**AMENDMENT TO THE APPLICATION TO THE
OHIO POWER SITING BOARD
FOR A CERTIFICATE OF ENVIRONMENTAL
COMPATIBILITY AND PUBLIC NEED**

**OPSB CASE NO.
19-1435-EL-BTA**

**Dennison - Yager 138 kV
Transmission Line Rebuild Project
July 2019**

**American Electric Power
Ohio Transmission Company**

Exhibit 3: Routing Difficulties

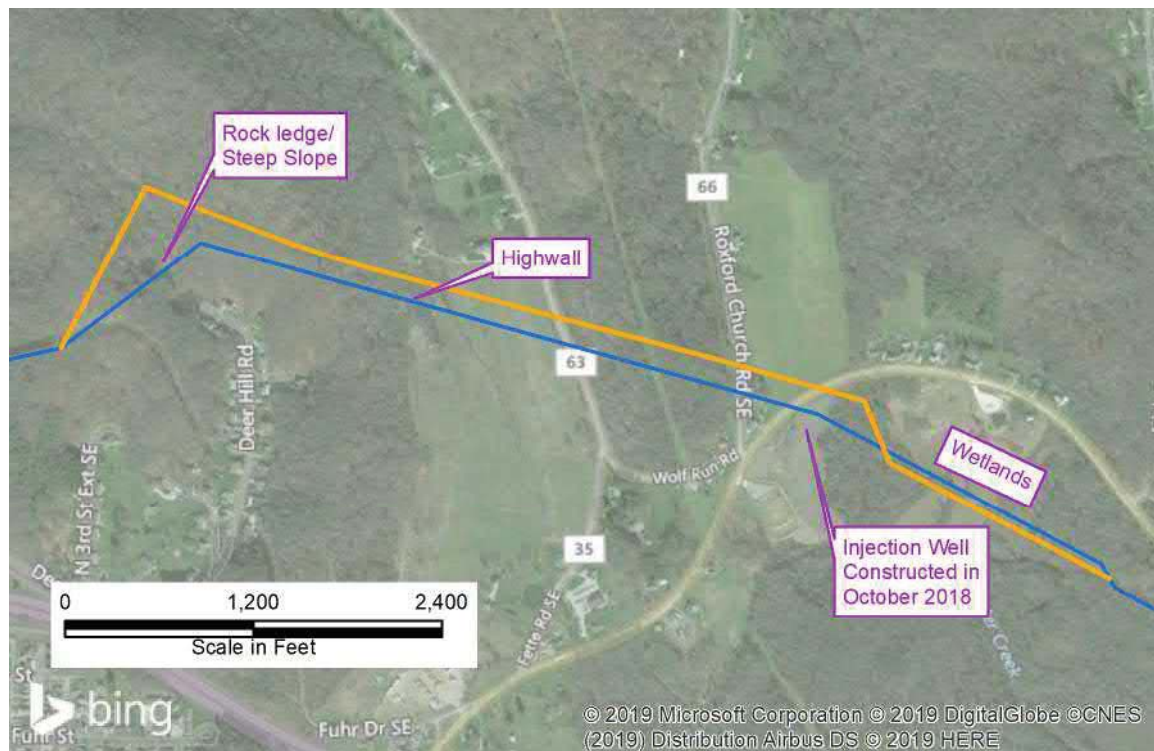
Difficult topography is prevalent throughout the western portion of the Preferred Route. Specifically, a rock ledge at the western end created a geotechnical challenge and safety hazard for access road construction and long-term maintenance access. The reroute offers an improved alignment that would provide greater safety for construction and long-term maintenance efforts.

In addition, during acquisition of easements and civil surveying, AEP Ohio Transco discovered an injection well application with the Ohio Department of Natural Resources (“ODNR”). The injection well is located just east of U.S. 250 and immediately adjacent to the approved centerline within the proposed right-of-way (“ROW”) as shown in Exhibit 2. In the interest of safety, AEP Ohio Transco shifted proposed structures 48 and 49 north to avoid the injection well.

As a result of the shifts caused by the rock ledge and injection well described above, AEP Ohio Transco shifted Structures 34-47 north of the original centerline to maintain the structures as tangent design structures, which require small diameter footprints compared to angle structures. These shifts were discussed with the landowners for concurrence.

Finally, continuing east from Structure 49 would result in crossing a large wetland complex. While the OPSB-approved route also crosses these wetlands, a more northerly crossing would result in additional wetland impacts. Therefore, the amended route turns to the southwest and parallels the OPSB-approved route to reduce wetland impacts.

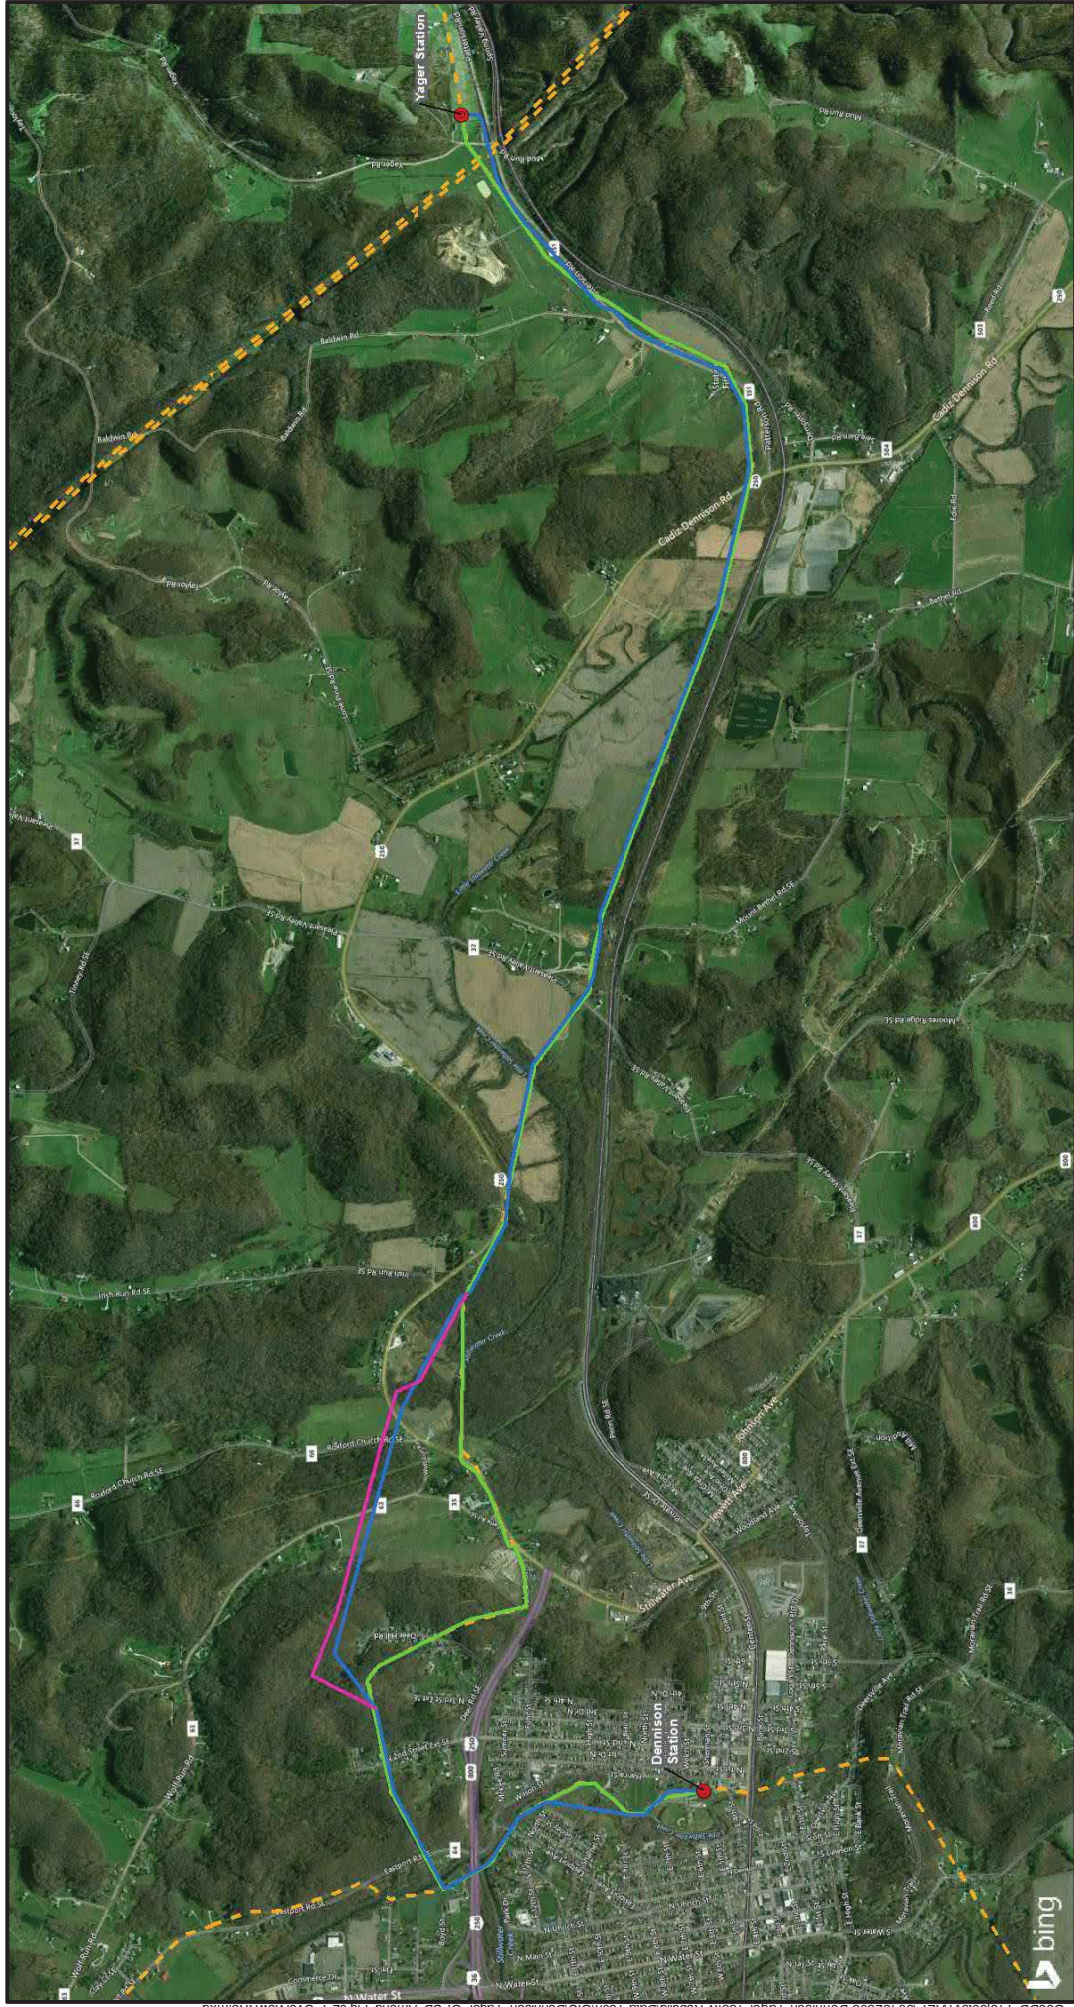
Text provided in the July 22, 2016 Application filing remains unchanged. A revised project overview is provided in **Revised Figure 02-1**.

REVISED FIGURE 05-1
PREFERRED AND ALTERNATE
ROUTES PROJECT AREA

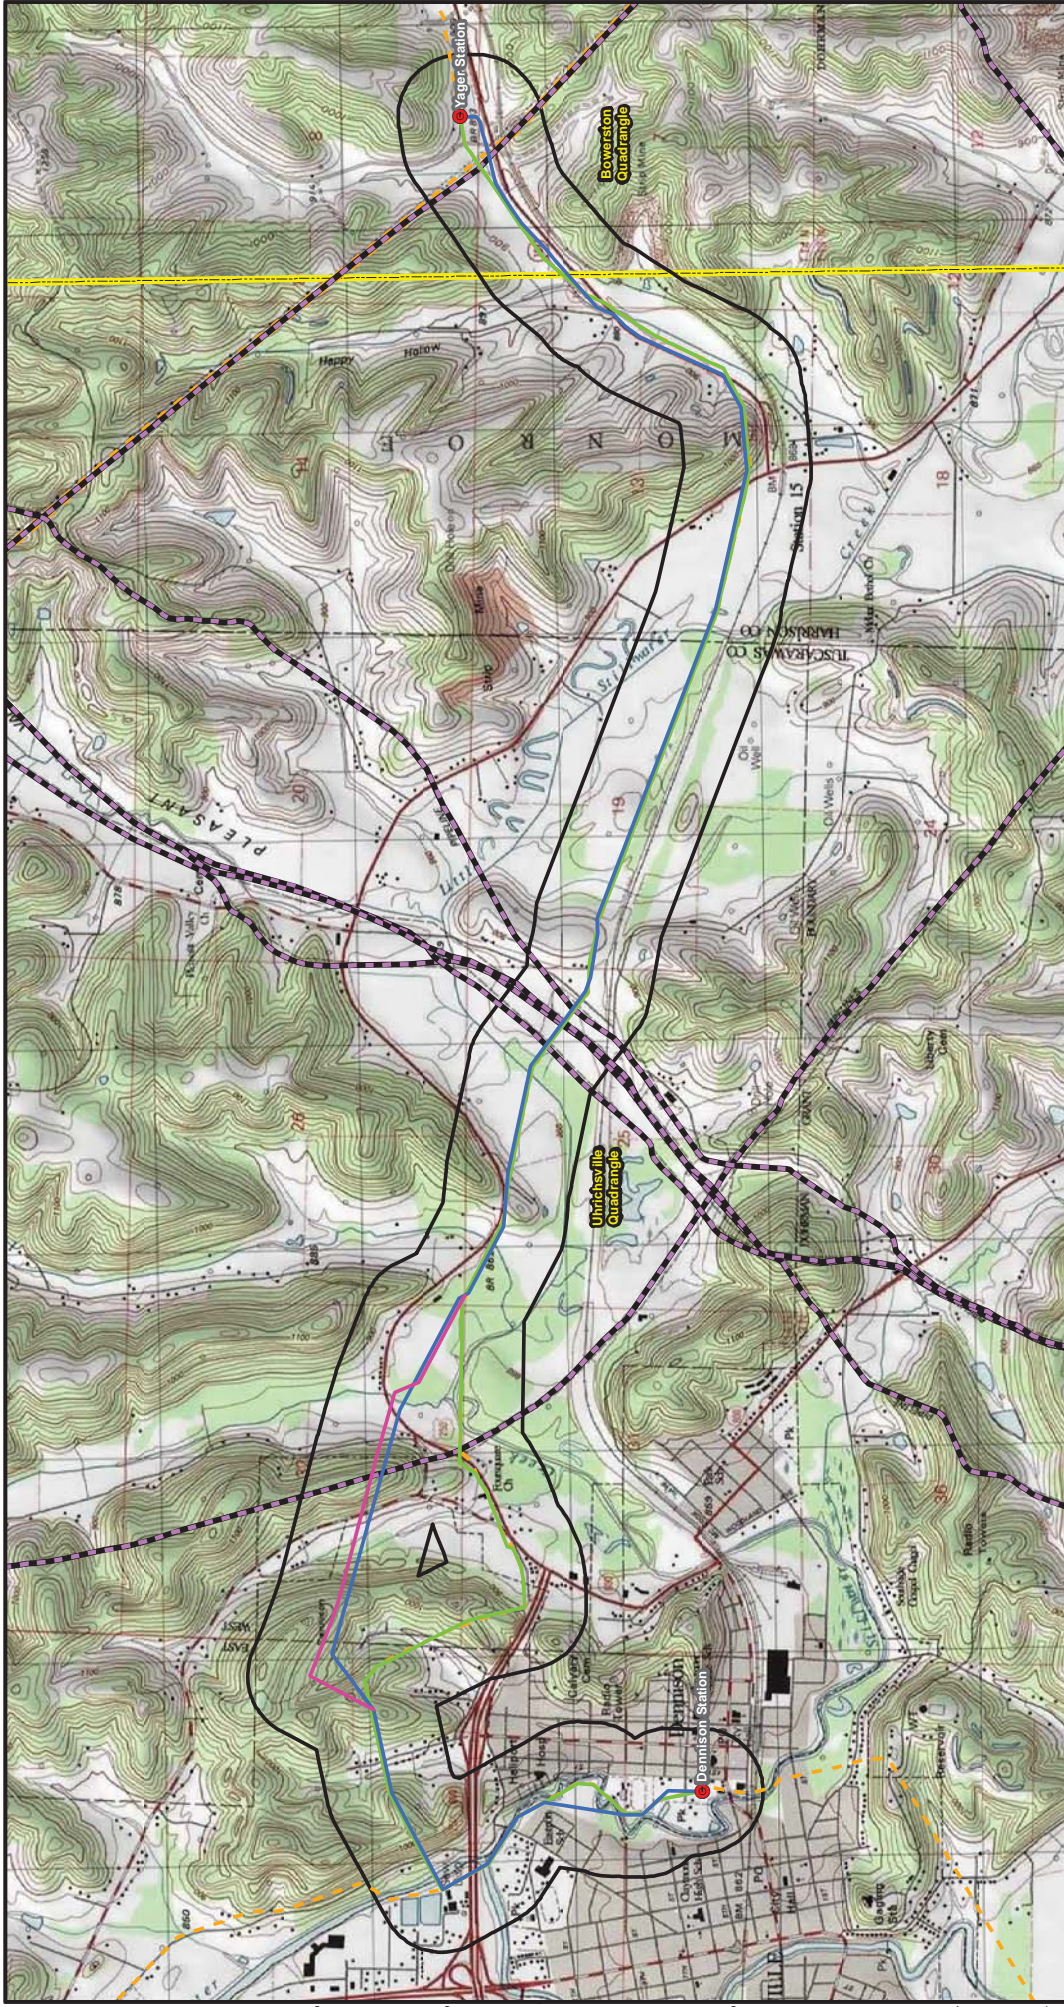
Text provided in the July 22, 2016 Application filing remains unchanged. **Revised Figure 05-1** provides a map at 1:24,000-scale showing the Amended Preferred Route, Approved Route, and Alternate Route.

The Preferred Route is approximately 7.2 miles in length and crosses approximately ~~59~~ 62 parcels. The Alternate Route is approximately 7.4 miles in length and crosses approximately 76 parcels.

REVISED FIGURE 08-1B
ECOLOGICAL FEATURES
AMENDED PREFERRED ROUTE
ROW & SURVEY CORRIDOR

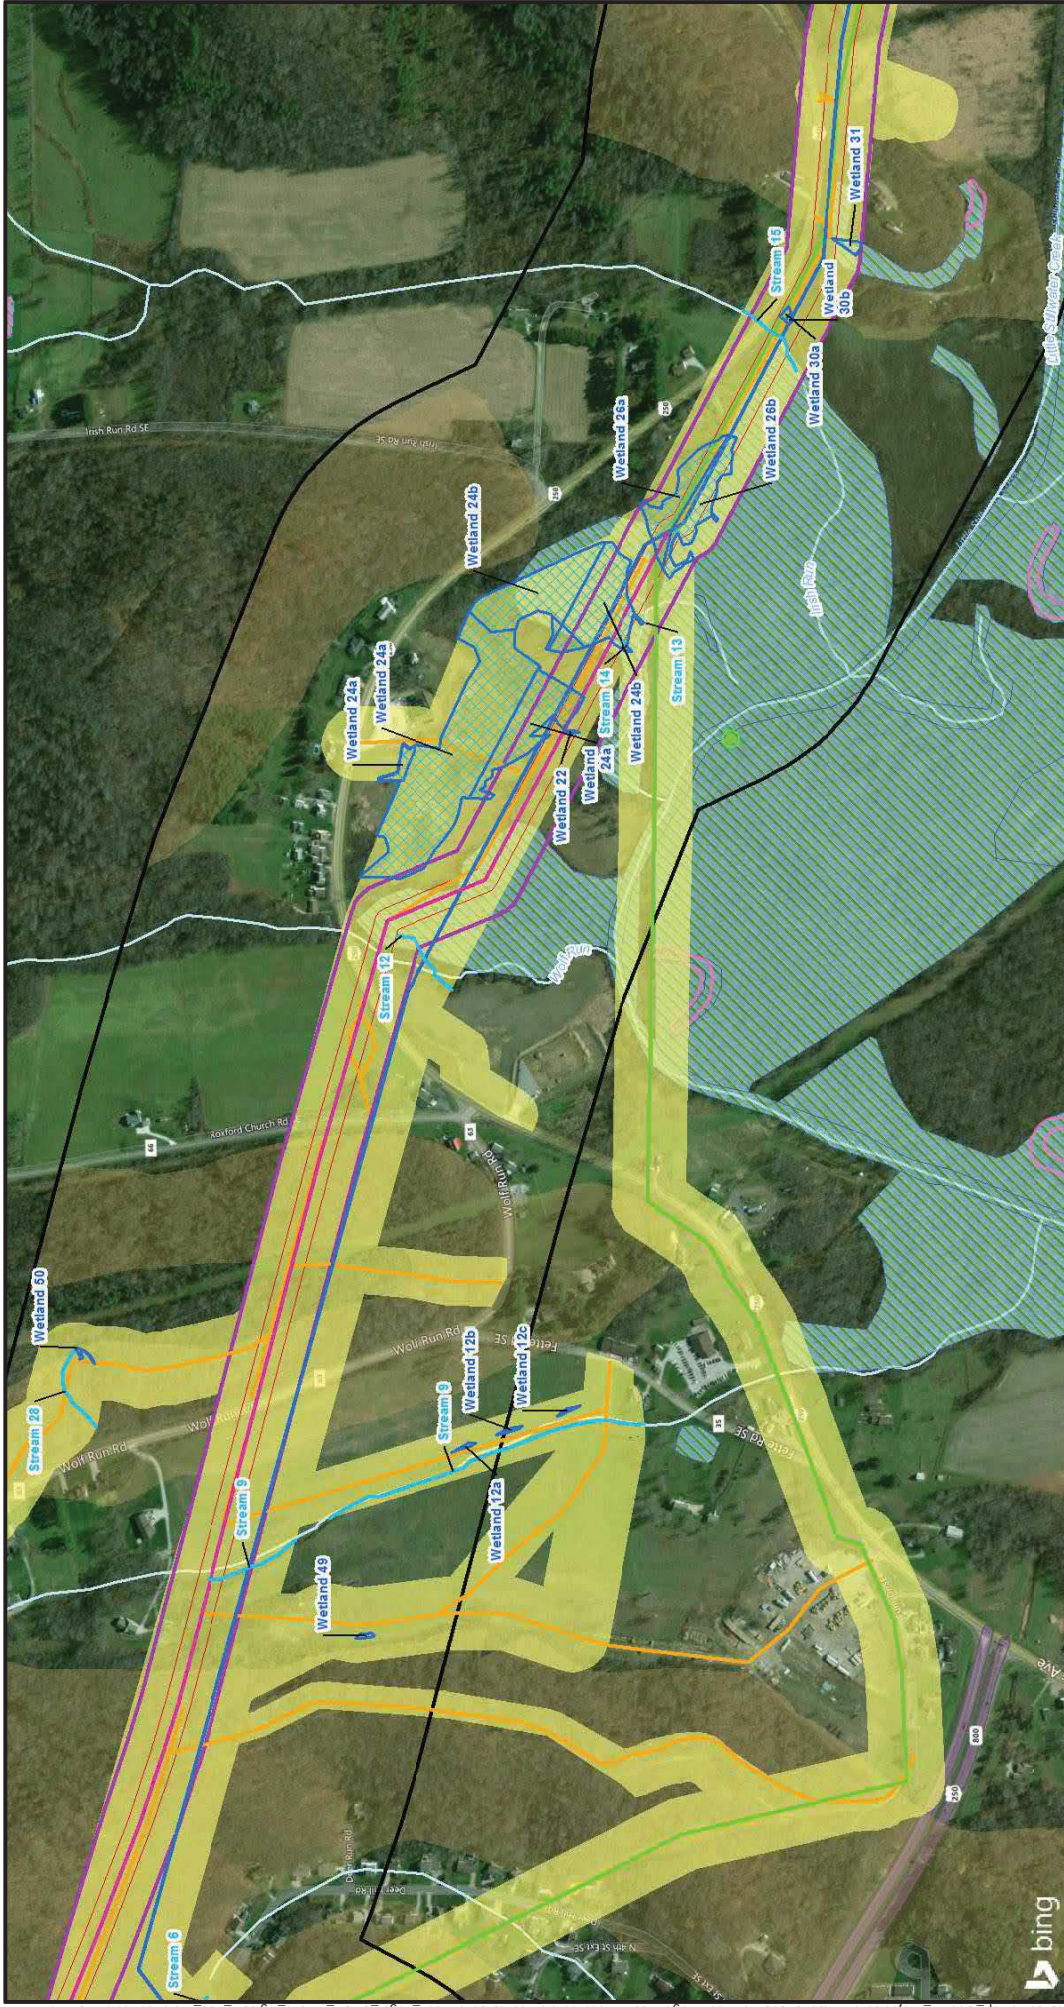
~~Forty-four~~ Forty-five wetlands were identified within the survey corridor along the Preferred Route, with a total of ~~21.35~~ 19.80 acres within the survey corridor and ~~7.05~~ 6.19 acres within the proposed ROW. ~~Twenty-three~~ Twenty-five of these wetlands are crossed by the Preferred Route centerline, for a total length of ~~2,968~~ 2,613 linear feet. ~~Forty-three~~ Forty-two wetlands were identified within the 300-foot survey corridor along the Alternate Route, with a total of ~~20.6~~ 20.16 acres within the survey corridor and ~~6.38~~ 7.07 acres within the proposed ROW. Fifteen of these wetlands are crossed by the Alternate Route centerline for a total length of 2,839 linear feet. Nine wetlands were identified within the 200-foot corridor of proposed access roads that extend beyond the Preferred and Alternate route survey areas, with a total of 2.04 acres. Two of these wetlands will be crossed by an access road using construction matting or other Best Management Practices (BMPs), which is further discussed in Section 4906-5-08(B)(3)(c). Representative photographs of wetlands identified during the field reconnaissance are included in **Appendix 08-1**. Corresponding USACE and ORAM forms completed during the wetland delineation are included in **Appendix 08-2**. Field delineated wetlands within the survey corridor are mapped on **Figures 08-1A through 08-1N, 8D through 08-1G, and Revised Figures 8B and 8C** for the Amended Preferred Reroute and are summarized in **Revised Table 08-1**.

~~Twenty-one~~ Twenty-two streams were identified within the survey corridor along the Preferred Route, with a total of ~~12,606~~ 12,865 linear feet within the survey corridor and ~~3,122~~ 3,031 linear feet within the proposed maintained ROW. Fourteen of these streams are crossed by the Preferred Route centerline.
